SUBJECT: NuScale Power, LLC Supplemental Response to NRC Request for Additional Information No. 361 (eRAI No. 9285) on the NuScale Design Certification Application

NuScale Supplemental Response to NRC Request for Additional Information eRAI No. 9285

NRC Question No.: 12.03-41

DCD Figure 11.4-2a: “Process Flow Diagram for Wet Solid Waste,” and DCD Figure 11.4-2b:

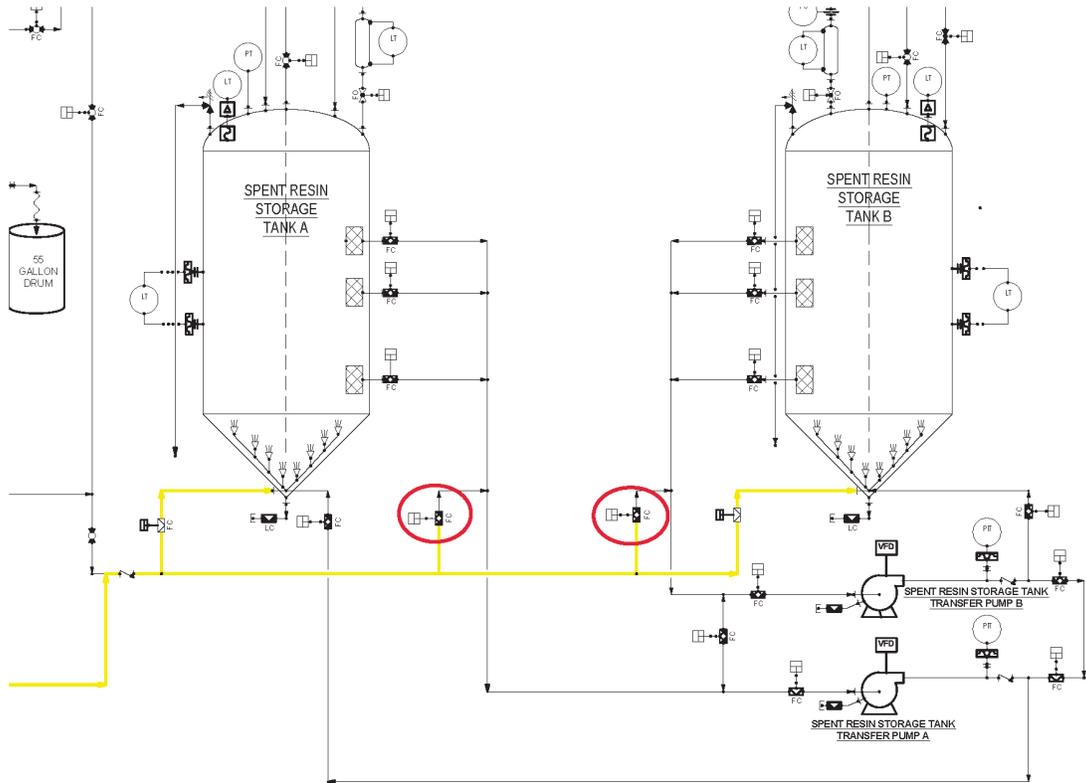
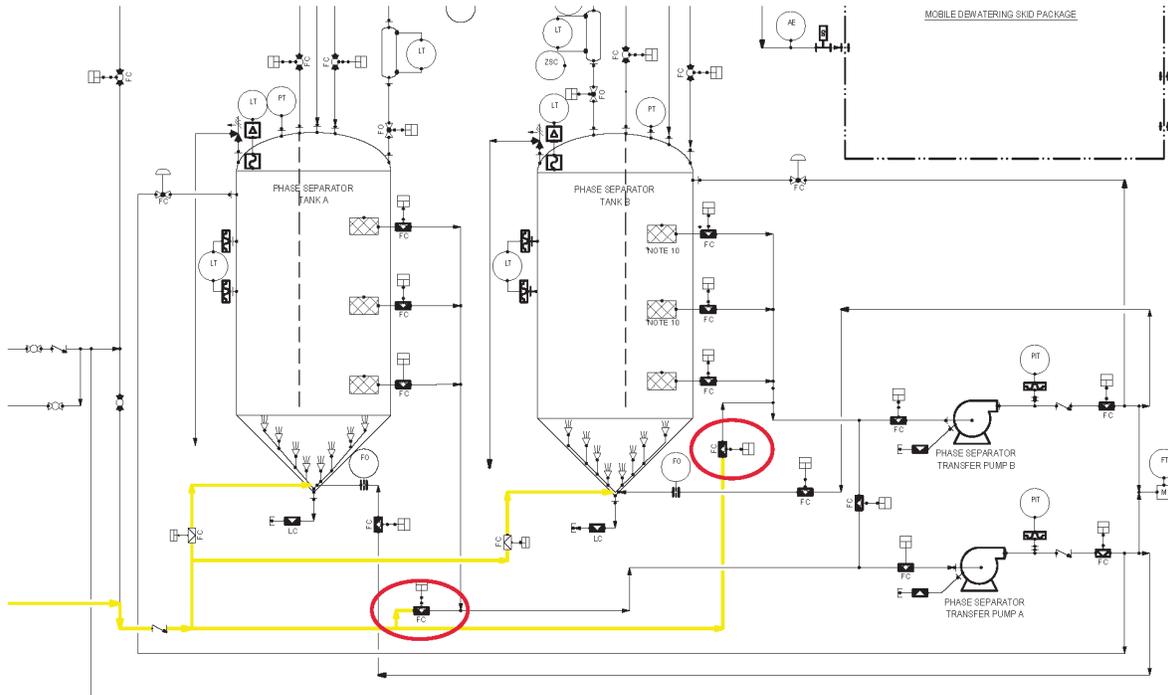
“Solid Radioactive Waste System Diagram,” show a line from the Service Air system that is separated from the suction of the resin transfer pumps by a single isolation valve. The use of a single isolation valve increases the risk for air intrusion due to valve leakage or misalignment. Based on information made available to the staff during the RPAC Chapter 12 Audit, the suction isolation valves for the pumps appear to be diaphragm disk valves. This information appears to be consistent with DCD Section 11.4.2.5.3, “Piping and Valves,” which states that valves in slurry transfer lines are full-ported ball valves and liquid process valves are diaphragm valves. Operating experience is available (e.g., Electric Power Research Institute (EPRI) Technical Report (TR) 105852 Volume 1 “Valve Application, Maintenance, and Repair Guide,”) to the staff that indicates that leaks past seats of these types of valves can occur as a result of poor stem travel adjustment, diaphragm age and over setting the stem travel. Typically, these types of valves are not in a periodic performance testing (i.e., leakage testing) program, and the staff has not seen any information that indicates that they are in a performance testing program.

The physical arrangement of the service air line with the resin transfer pumps, and the absence of design features to prevent pump air binding, or pump damage, does not appear to address operating experience (e.g., EPRI TR-1026498 "Report of the Expert Panel on the Effect of Gas Accumulation on Pumps), and may result in increased ORE.

- Please describe the type of pump (e.g., sealed) used for the resin transfer pumps
- Please describe the design features provided to prevent air intrusion into the pumps and seals,
- Please describe the design features provided for removing air from the pump/seal, should air intrusion occur,
- Please describe any level controls provided to maintain water in the resin transfer pumps,
- As necessary, revise the DCD Section 12.3-12.4 to include information related to ensuring the reliability of the resin transfer pumps,

During a public NRC clarification phone call on 5/22/2018, the NRC inquired about the purpose of specific valves related to air sparging and backwashing operations. For the valves circled in red below, the purpose is to provide a second barrier between service air and the suction side of the associated transfer pump. Service air is not used to backwash the decant screens on the side of the tanks. Demineralized water is used to backwash the decant screens. A clarifying statement is added to FSAR Section 11.4.2.2.1 to explain that air is not used to backwash the decant screens.

If necessary, service air can be used to fluff the resins through the sparging nozzles at the bottom of the SRST and PST. Air is not used to backwash the tank decant screens.
